development review board **REPORT**

Meeting Date:	November 17, 2022
General Plan Element:	Character and Design
General Plan Goal:	Foster quality design that enhances Scottsdale as a unique
	southwestern desert community.

Ashler Hills Park	Request for approval of project plans for a new park, including public art
51-DR-2021	locations, on a +/- 15-acre site.

FIGURE 2-1.1 AMBIENT LIGHTING ZONES

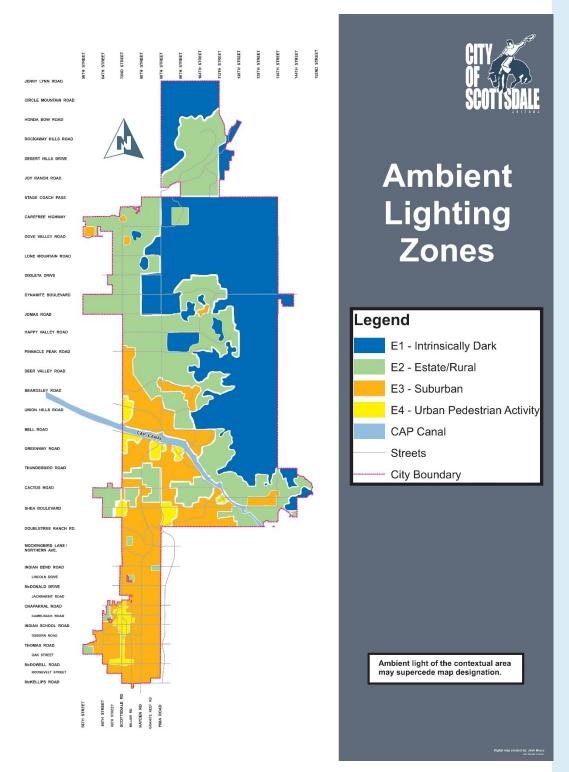
The Illuminating Engineering Society (IES) developed the concept of Ambient Lighting Zones to provide appropriate lighting design levels based on the context of the area. On Scottsdale's Ambient Lighting Zones Map (DSPM Figure 2-1.1), Las Piedras is located within Ambient Lighting Zone E-2 Estate/Rural Areas. Of this zone, DSPM states: "Lighting levels are generally low; there is often an expectation in the neighborhoods that the lighting levels remain low." Las Piedras is at the base of a small mountain located within Ambient Lighting Zone E-1 Intrinsically Dark Areas. DSPM describes this zone as: "There is little nighttime activity and few outdoor lighting sources."

EXHIBIT A

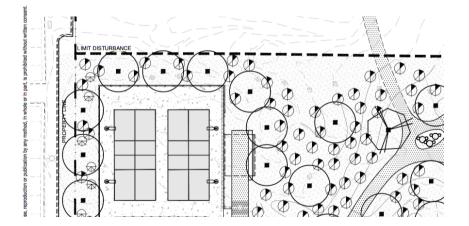
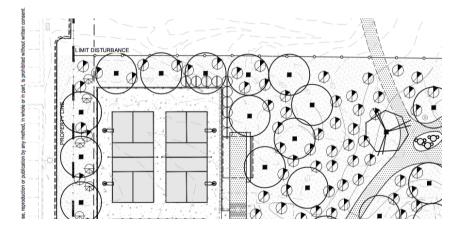
The lighting has changed throughout this process. Between the first and second Open House, the lighting became taller. Then, in response to our feedback, the applicant reduced lighting height and in some cases, lumens. We simply want to lock in these changes. In the absence of a protective stipulation, the applicant can revert back to one of the previous lighting plans, or submit a new plan, when the project goes before DRB for design approval. It would be inappropriate for the applicant to make changes to obtain MUMSP approval and then reverse those changes once approval is granted. Requested stipulation LP6 affords us some protection while providing the applicant flexibility.

Figure 1. One-half mile radius from park site (shaded Red)

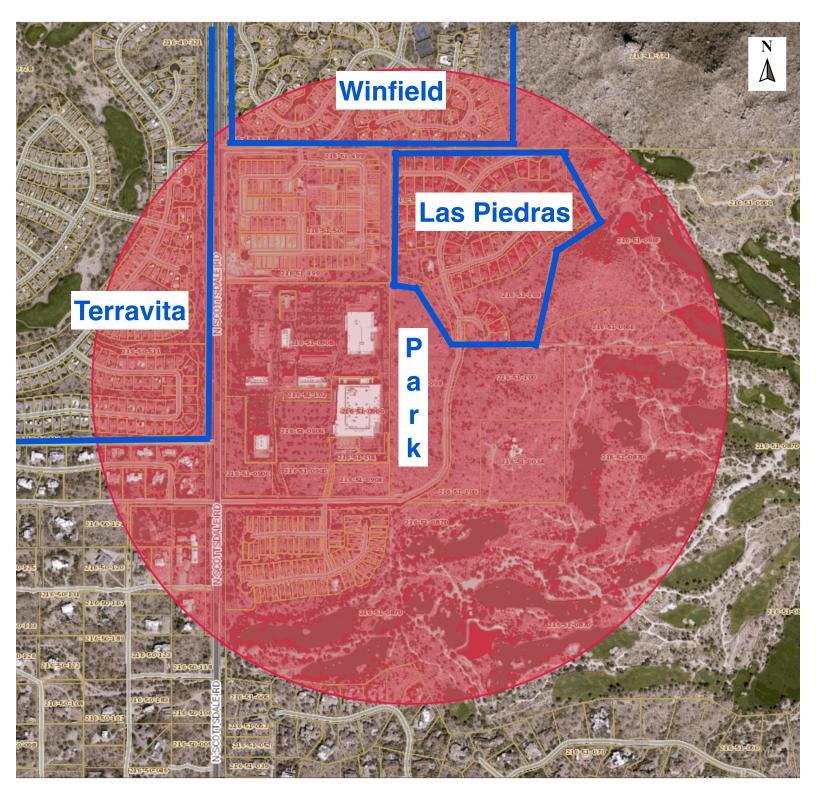
Accordingly, when planning the development of a new Neighborhood Park, the City is to consider the recreational needs and preferences of residents within a one-half (½) mile radius. See Figure 1 attached.

Figure 2. Park extends into Las Piedras, to within 160 feet of homes

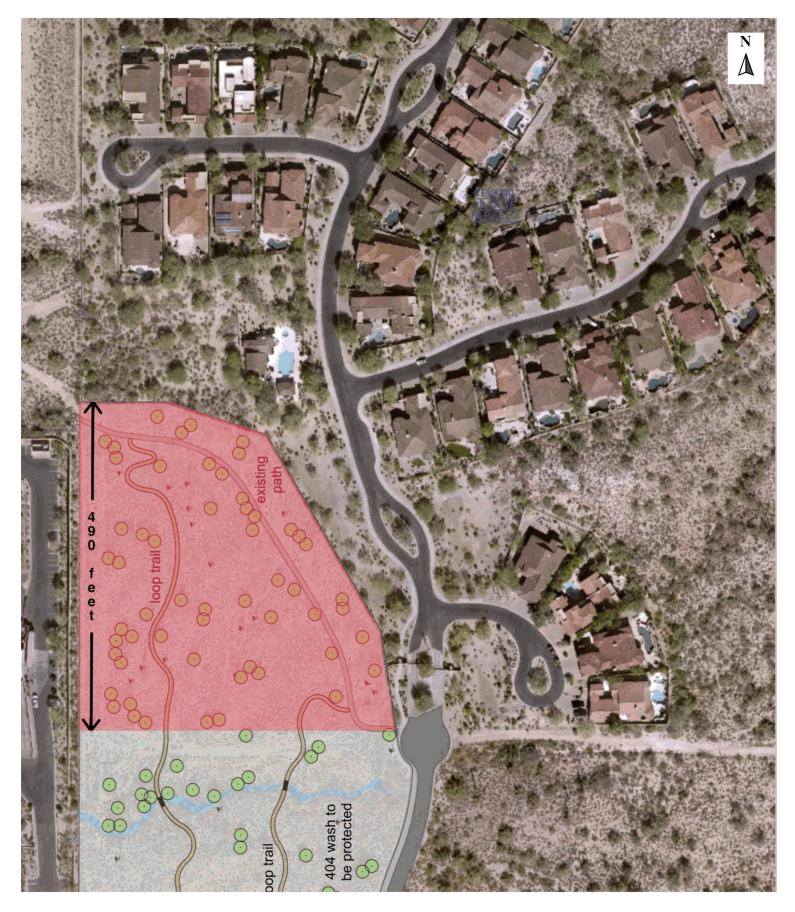
Our community, Las Piedras, will be directly and significantly impacted by the development of Ashler Hills Park. The park parcel is contiguous with our southwestern border and extends 490 feet – nearly one-third of its total length – "into" our community. See Figure 2 attached. It is only 160 feet from the nearest home in Las Piedras. Ten homes are within 300 feet.

Figure 1. One-half mile radius from park site (shaded red)

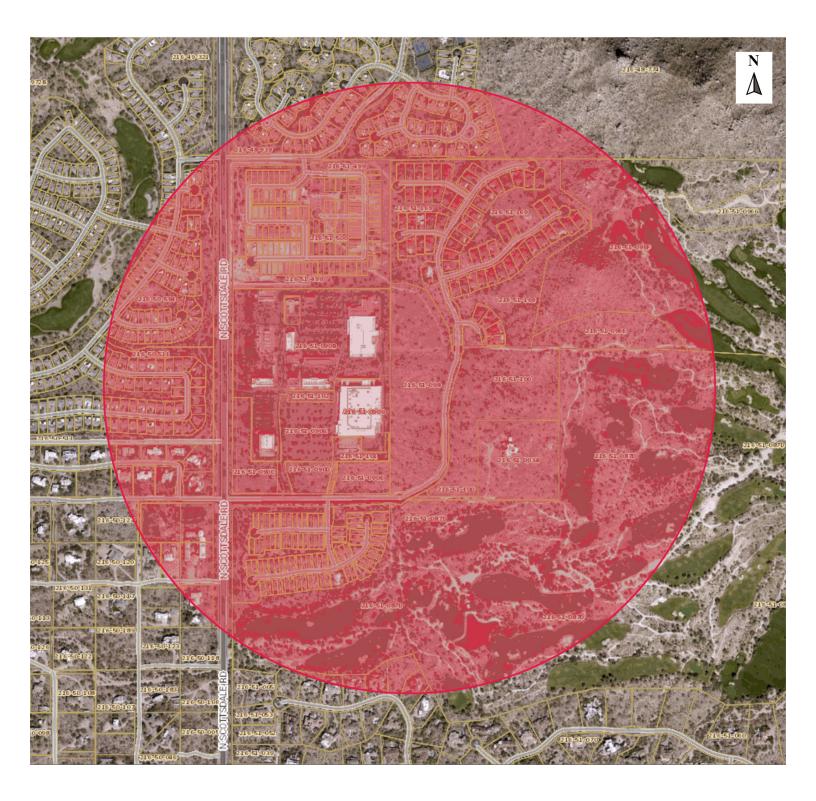
Accordingly, when planning the development of a new Neighborhood Park, the City is to consider the recreational needs and preferences of residents within a one-half (½) mile radius (Figure 1 attached).

Figure 2. Park extends into Las Piedras, to within 160 feet of homes

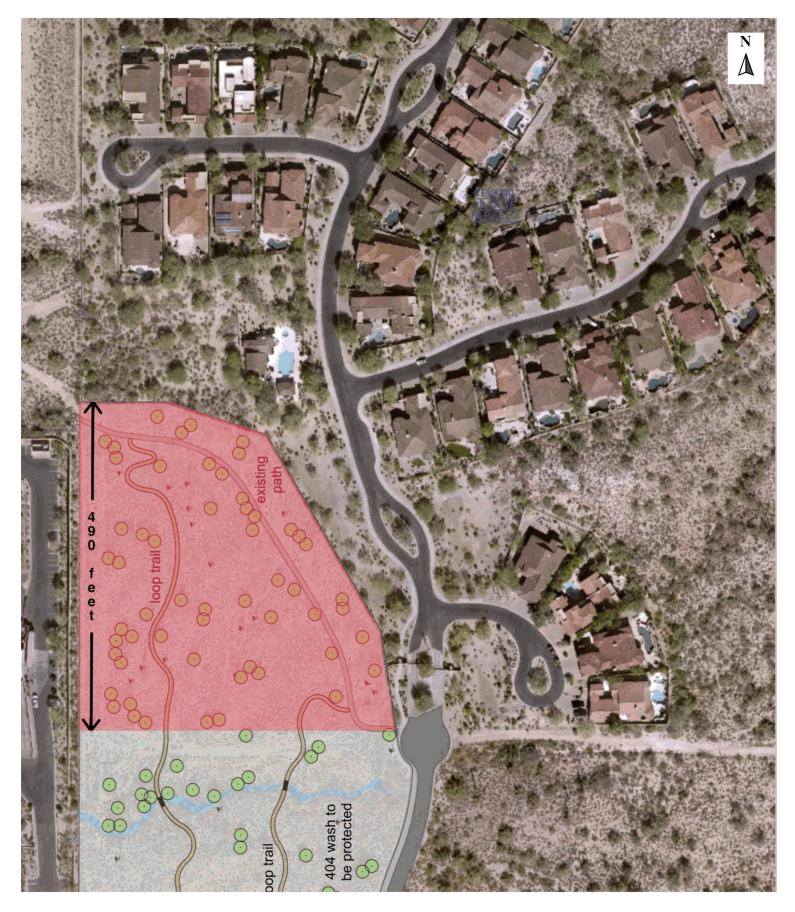
Our community, Las Piedras, will be directly and significantly impacted by the development of Ashler Hills Park. The park parcel is contiguous with our southwestern border. The park parcel extends 490 feet – nearly one-third of its total length – "into" our community (Figure 2 attached). The park parcel is only 160 feet from the nearest home in Las Piedras. Ten homes are within 300 feet.

Any park development that occurs in the orange-shaded area of Figure 2 is virtually within our community. We appreciate that, in the current proposed site plan, "improvements" in this area are limited to the loop trail and existing path. We note that this area is in keeping with a designated focus of Neighborhood Parks: to preserve open spaces (Community Services Master Plan 2015). In addition, undisturbed portions of this area may count toward the development's Natural Area Open Space (NAOS) requirement.

Figure 6. Blind curve safety hazard at City's proposed access (park entrance)

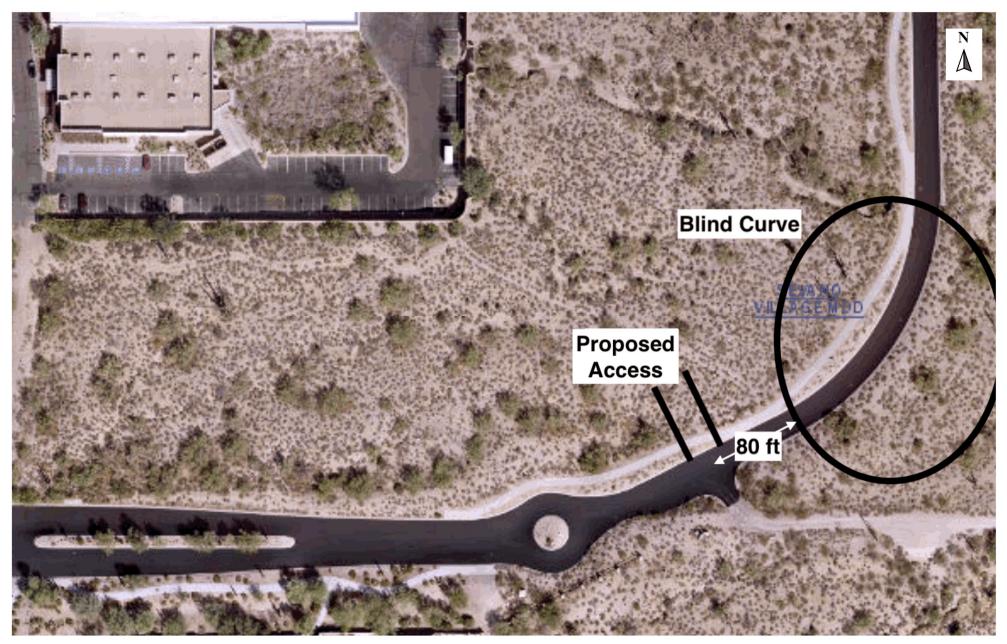
At the park site, east-west Ashler Hills Drive turns to become north-south 74th Way. The northeast portion of that long turn has the shortest radius of curvature; this sharp curve is a blind curve (Figure 6 attached).

Drivers travelling S-W out of the blind curve and drivers entering and exiting the park would not see each other until they are within 80 feet of each other – a distance far short of the Minimum Stopping Sight Distance and the Minimum Tangent Approaching Intersection required per DSPM (Appendix 5-3A).
